ARCHITECT'S SUPPLEMENTAL INSTRUCTIONS

PROJECT:	The Reserves at Magnolia New Apartment Complex Denton, TX	Report No.	One (1)
OWNER:	Overland Property Group Dan Maximuk 234 N. Santa Fe Ave, Suite A Salina, KS 67401	Date	Oct. 22, 2024
CONTRACTOR:	Snyder Construction Group 4820 N. Town Centre Dr. Ozark, MO 65721	Architect's Proj No.	21-3205
		Contract For:	General Construction Mechanical, Electrical

Please Note: Drawings and Specification Edits associated with this ASI are dated as **7-17-2024**. This date above is the date this ASI was issued.

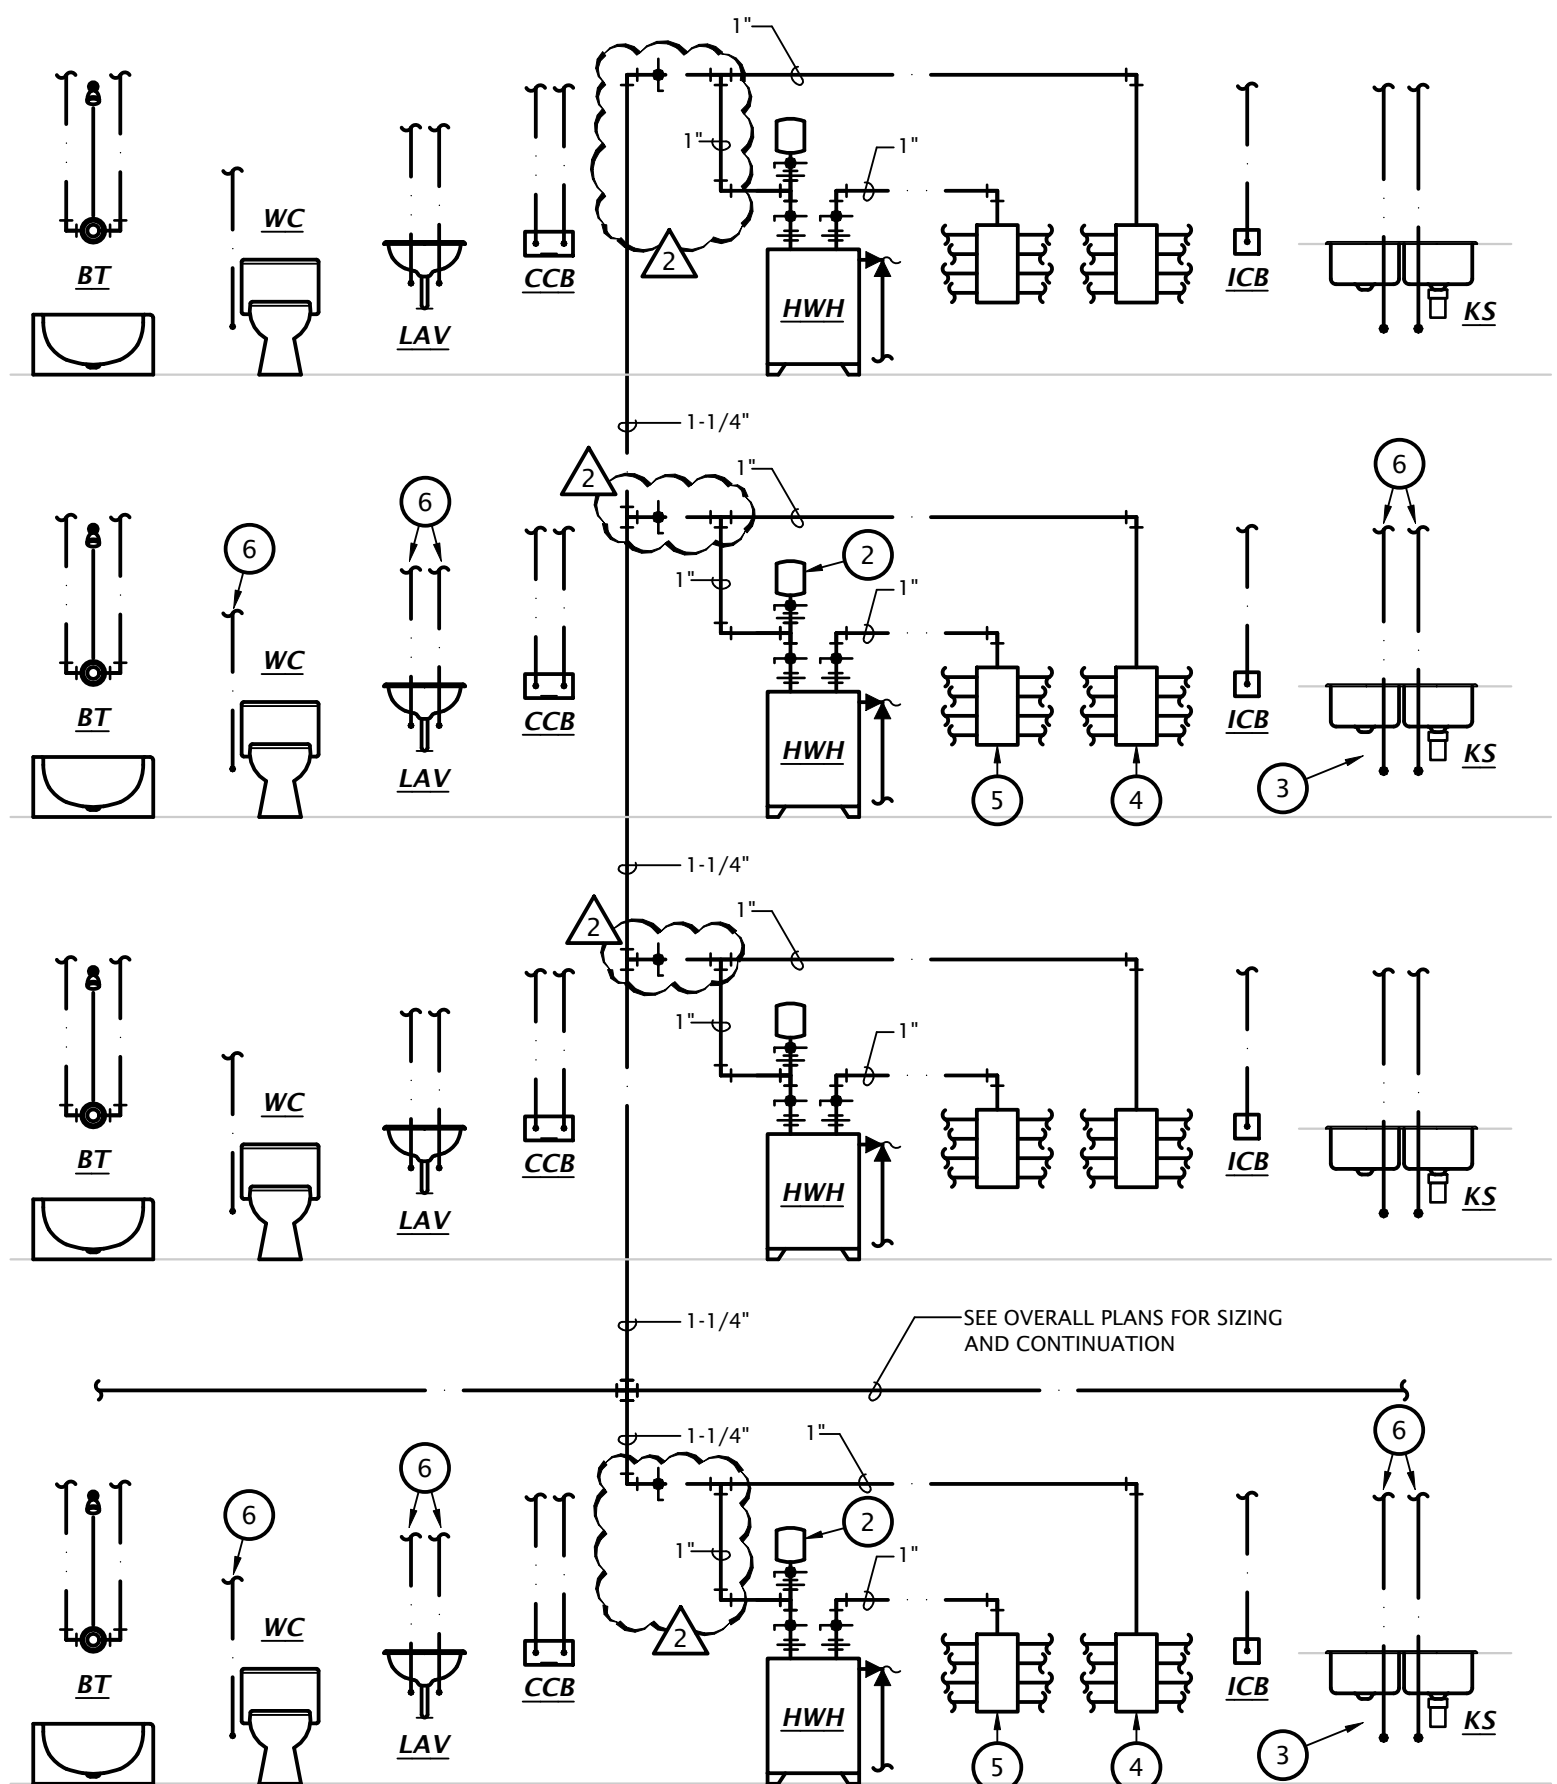
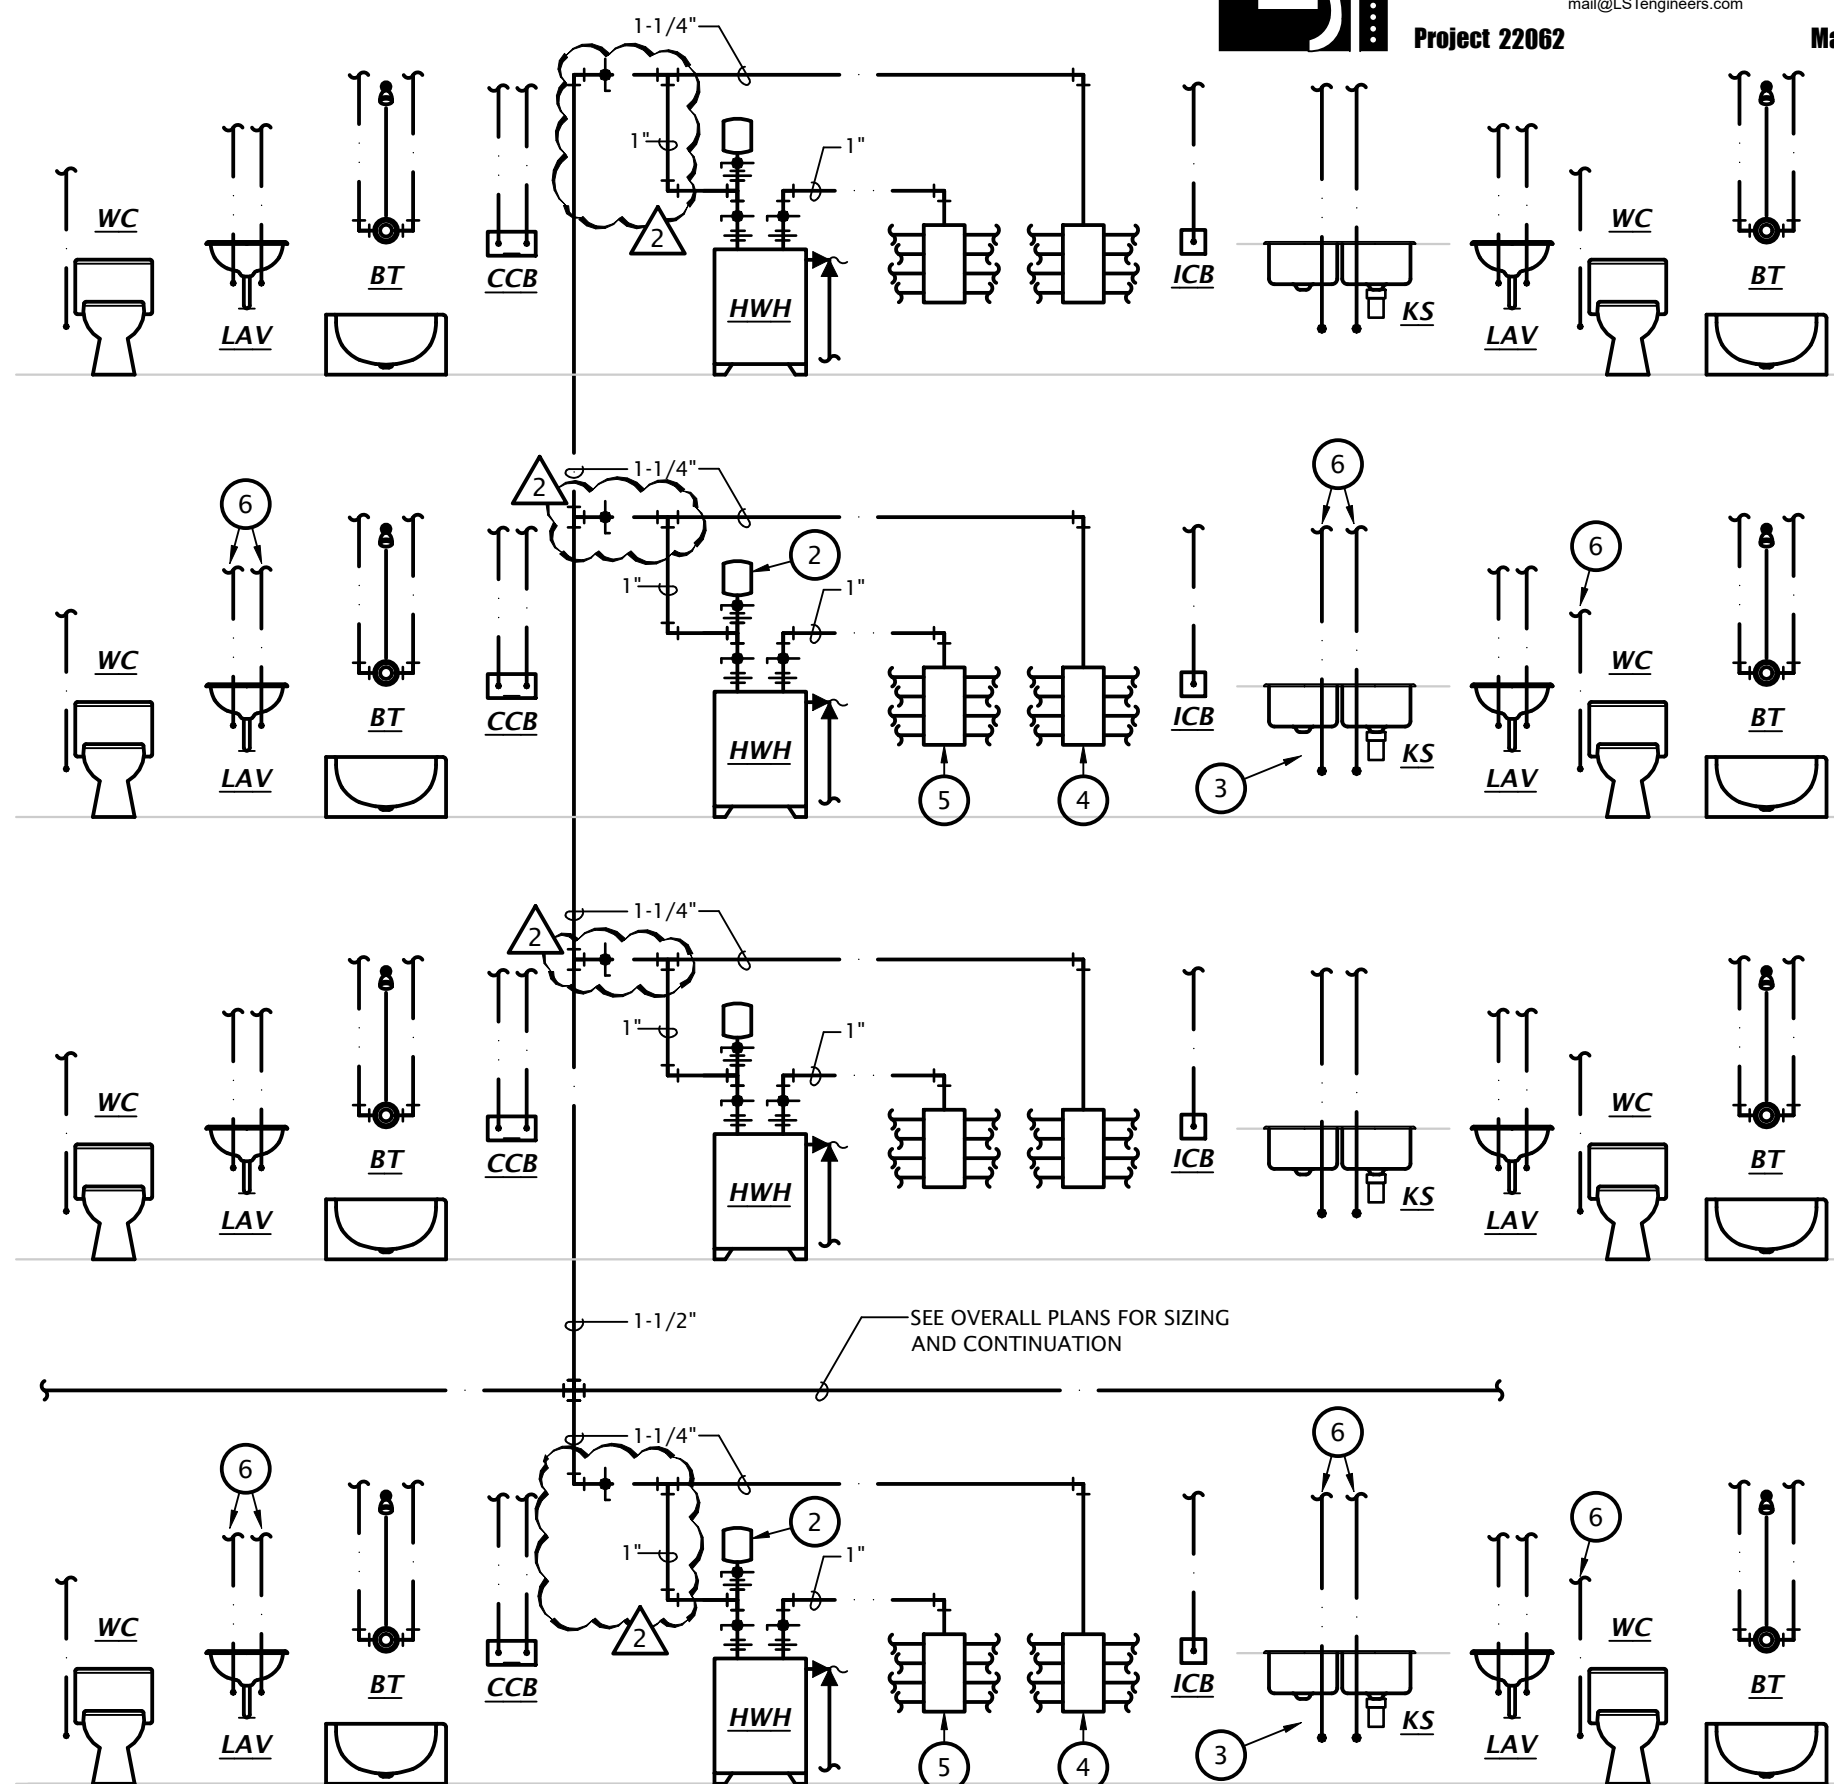
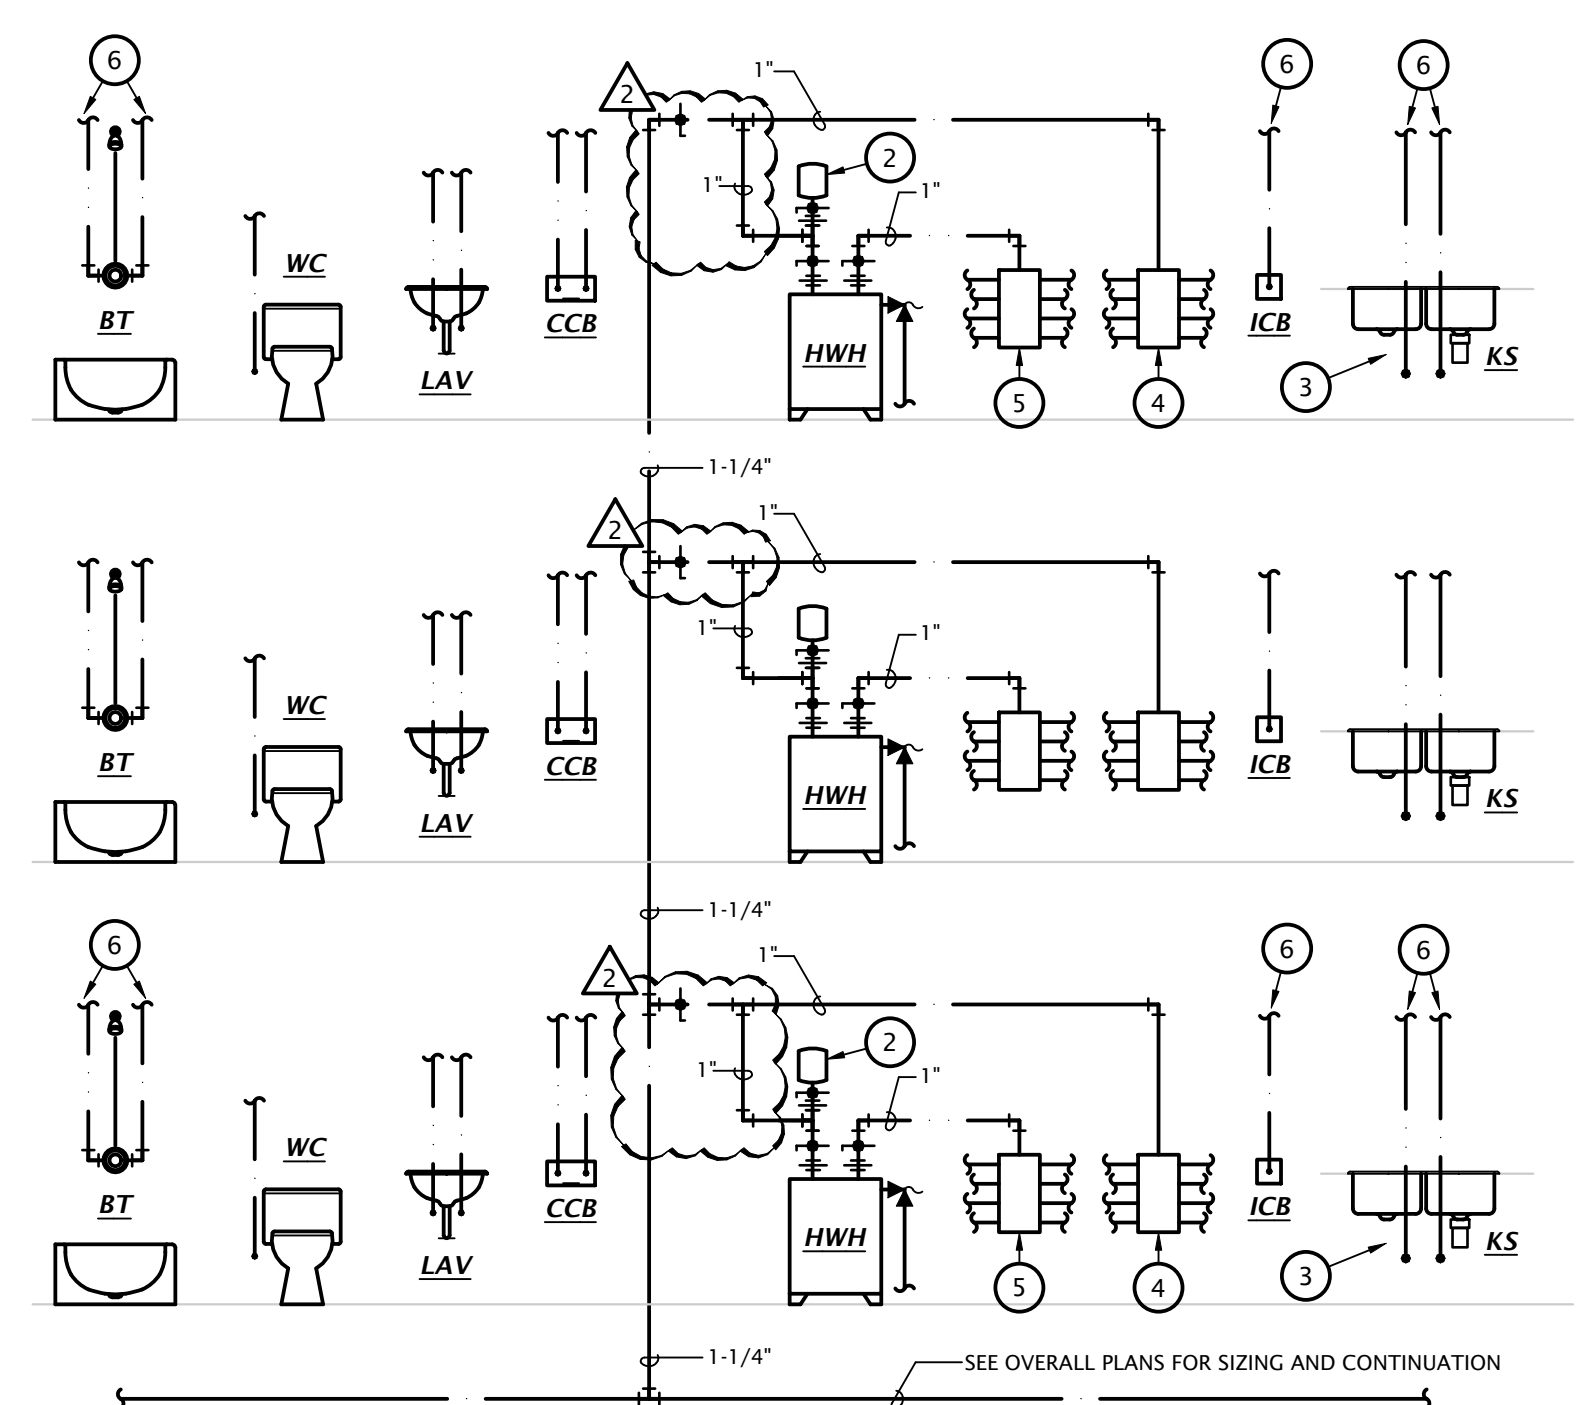
- 27) Utilize a Watts model PLT-5 or equal expansion tank at HWH-A water heaters in lieu of the specified Watts Model DETA-12 expansion tanks. (VE Item #32) Reference revised Sheet P6.1

1. NOT USED.
2. PROVIDE WATTS MODEL PLT-5 EXPANSION TANK. (TYPICAL)
3. PROVIDE 1/2" VALVED HOT WATER CONNECTION TO DISHWASHER. (TYPICAL)
4. COLD WATER SUPPLY PEX MANIFOLD. (TYPICAL)
5. HOW WATER SUPPLY PEX MANIFOLD. (TYPICAL)
6. ROUTE HOT AND COLD WATER PEX AS REQUIRED FROM FIXTURE TO APPROPRIATE MANIFOLD. SEE P4 SHEETS FOR SIZING AND CONTINUATION. (TYPICAL)
